17.4S Reliability Assurance Program

17.4S.1 Identification of Site-Specific SSCs for D-RAP

Figure 17.4S-1 Reliability Assurance Process

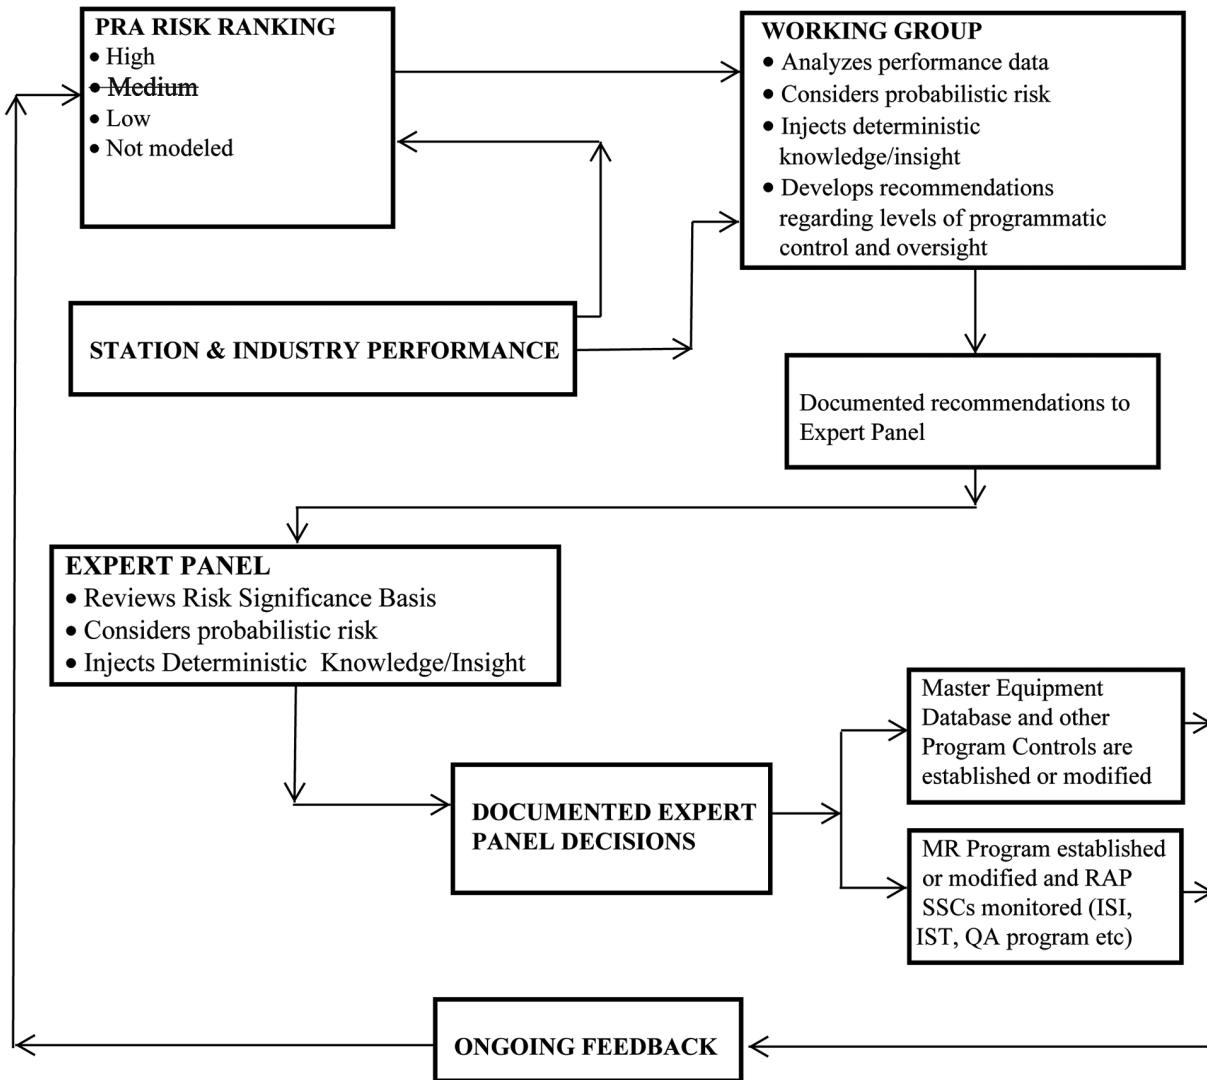
Figure 17.4S-2 ~~Reliability Assurance Program + Maintenance Rule Program + QA Program~~

~~Note 1: SSCs with a Risk Achievement Worth (RAW) value of $RAW \geq 2.0$ or a Fussell-Vesely (FV) value ≥ 0.005 (i.e. greater than PRA low) are included in RAP. SSCs in RAP are included in the MRP as High Safety Significant SSCs.~~

~~Note 2: PRA risk rankings are developed utilizing the process described in 17.4S.1.4.1.~~

~~Note 3: The deterministic questions are answered at the system function level as described in 17.4S.1.4.2.~~

~~Note 4: Final risk cannot be lower than PRA risk.~~

~~Note 5: The QAPD Part II applies full quality controls meeting 10 CFR 50 Appendix B. The QAPD Part III applies selected sections of Part II, targeted to those characteristics or critical attributes that render the SSC a significant contributor to plant safety.~~
